From: Katherine Brommage
Sent: 13 October 2016 14:33
To: Planning Comments
Subject: FW: Query 256 - FW: 3rd Party Planning Application - 15/01376/OUT - DTS 44306

Re: LAND EAST OF, BELL LANE, POULTON, CIRENCESTER, GLOUCESTERSHIRE , GL7

Mr/s Wigram commissioned Enzygo Ltd to produce a Flood Risk Assessment (FRA) during March 2015, in support of an outline planning application for a residential development to comprise a maximum of 11 units, with access roads, gardens and landscaped areas.

15/01376/OUT | Outline planning application for the erection of up to 9 dwellings and associated access (appearance, layout, landscape and scale reserved for future consideration) | Land East of Bell Lane Poulton Gloucestershire

Figure 5.1. OpenChan Calculation of Bridge Orifice

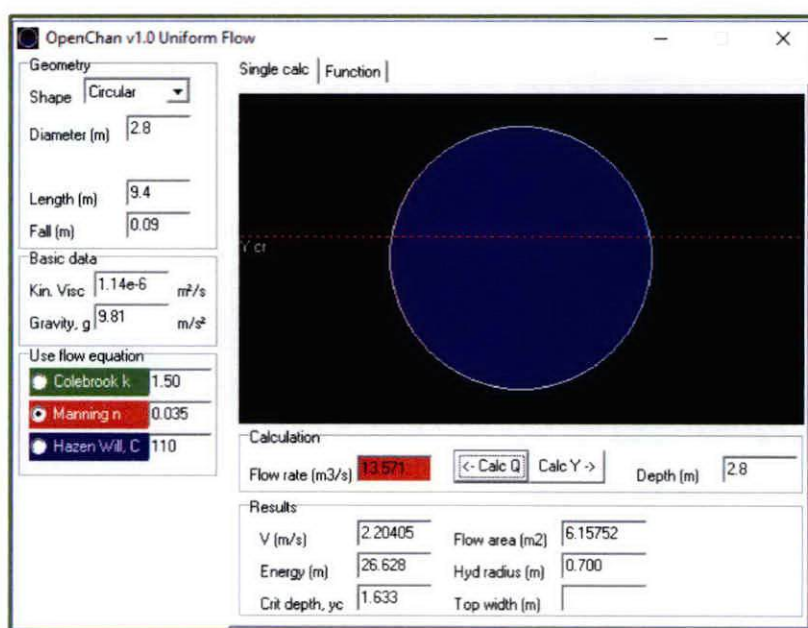
- The dimensions (length) of the bridge at London Road is incorrect in the Enzygo report – have their dimensions been checked? What are the implications if their calculations are based on incorrect measurement data?

The width of the bridge was measured using Ordnance Survey mapping, which was found to be approximately 18m (conveying $4.9\text{m}^3/\text{s}$). Measuring of the Ordnance Survey mapping may have led to inaccuracies. We accept the revised figure of 9.4m quoted by objectors, and provide the following calculations (see Figure 5.1), which demonstrate that the shortened bridge can convey a higher figure of $6.8\text{m}^3/\text{s}$ (half of flow rate set out below in Figure 5.1). Both the flows quoted above exceed the 1 in 100yr plus climate change flows calculated along the watercourse. The purpose of the capacity checks was to demonstrate that there is reasonable conveyance through the outfall drainage route. The fact that the bridge surcharges has no impact to the Development Site. The flood risk from the Site is based on surface water discharge, which has been demonstrated to be attenuated onsite to an acceptable return period, including climate change (see previous comments).

Figure 7.1. Highway Drainage Catchment

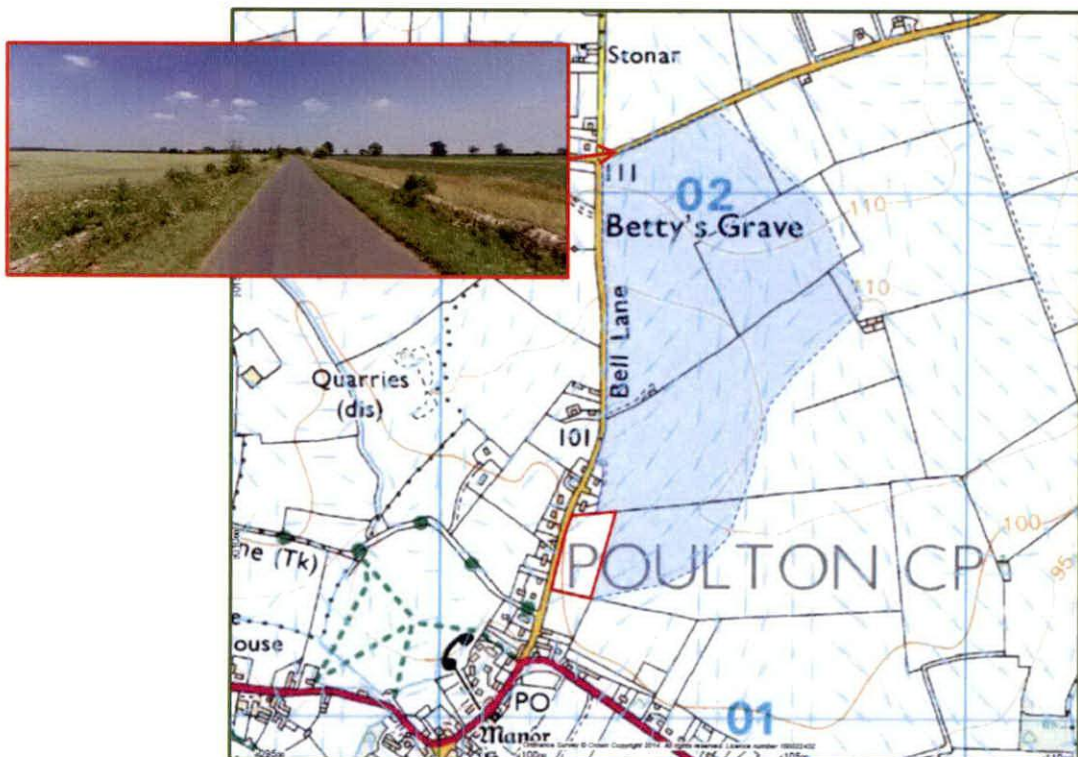
2. You have queried the huge reduction in catchment for the surface water arriving at the Eastern boundary of the site. What information have you received to justify this reduction bearing in mind that the drawing of the catchment area included in Enzygo's last submission appears to be arbitrary, actually cutting across flow lines? Mr Tough highlighted on the drawing that the flow arrows indicated a larger catchment area than stated.

6. Surface water flow arrows shown on the catchment area appear to have changed – they now flow in a different direction – we are concerned that the complete flow is not captured and therefore surface water run off calculation is incorrect (no attributed source for latest diagram at a lower level detail).

The initial catchment area investigation was to calculate the catchment contributing to flows into the highway drainage inlet (29.7 Ha), which was generated using LiDAR data (ground model, depicting local topographic levels). The initial investigations used readily available, but less accurate LiDAR data set, with the catchment boundary drawn visually around the flow pathway arrows.

Figure 7.1 below depicts the 29.7 Ha catchment, contributing to flows within the highway drainage. The catchment boundary was derived through a visually drawn line around the flow pathway arrows, and was previously submitted as part of a rebuttal response to a previous Gloucester County Council objection. The highway running east-west along the northern end of the catchment is topographically higher than land to the north, therefore would not contribute to the catchment area, and would divert flows east and west. This would also be influenced by a depression in the land along the north and southern boundary of the highway, and by stone walls (see image below, view looing east along highway). The properties to the north of the Site discharge surface water to the public foul network.

Figure 7.4. PDS Flow Pathway Analysis Extract

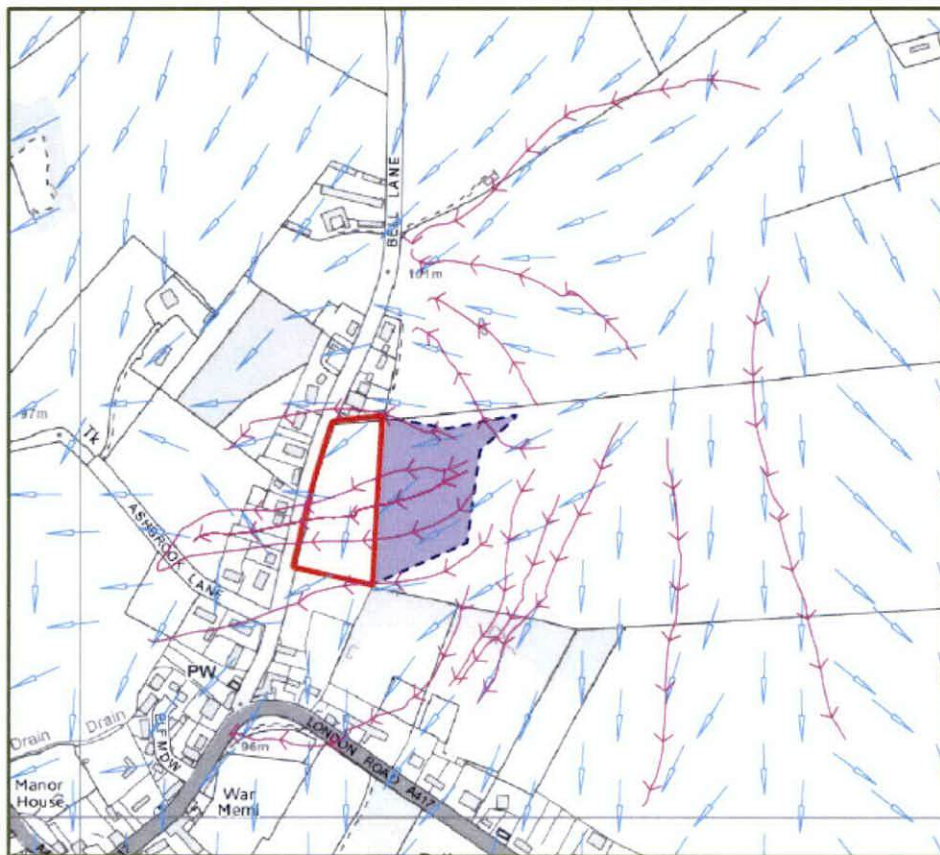
The Poulton Working Group have also submitted an image of a perceived catchment contributing to overland flow (from a catchment to the east of the Site), which would flow through the site (see Figure 7.3 [left]). The catchment appears to be derived from the flow pathway arrows within the catchment, previously produced by Enzygo. We assume that the catchment has been drawn visually around the flow pathway arrows. As stated above, Enzygo utilised PDS flow pathway analysis to more accurately refine the catchment area, which is much more accurate than a hand drawn catchment boundary. As such, there is insufficient evidence to demonstrate that the catchment to the east of the Site is bigger than 1.37 Ha.

Put simply, whilst the arrows are shown pointing towards the Site, the PDS flow pathway analysis refines the boundary, which means that the actual boundary is smaller than perceived by the arrows. An extract from the PDS flow pathway analysis has been included below within Figure 7.4. The flow pathway analysis is essentially a process of tipping a bucket of water at various points within and around the Site, and tracking the flow direction. This is represented by the pink flow pathway arrows.

Poulton Working Group have also misinterpreted the direction and number of flow pathway arrows between the flows pathways within the wider 29.7 Ha catchment, the 1.37 Ha catchment to the east of the Site, and the flow pathways within the Site boundary itself. The difference in direction and number of flow arrows is a function of the detail of the coverage trying to be depicted between the drawings. The zoomed-out map for the wider 29.7 Ha catchment is more generalised, and less data rich (i.e. fewer flow pathway arrows) (see Figure 7.3, [left]). The catchment for the 1.37 Ha catchment to the east of the Site as submitted by Poulton Working Group is based on the same zoom level. The flow pathway arrows within the Site is based on a zoomed-in map, which is more detailed and data rich (i.e. more flow pathway arrows) (see Figure 7.3, [right]). The zoom level used by Enzygo is determined by what level of information is considered appropriate for each drawing.
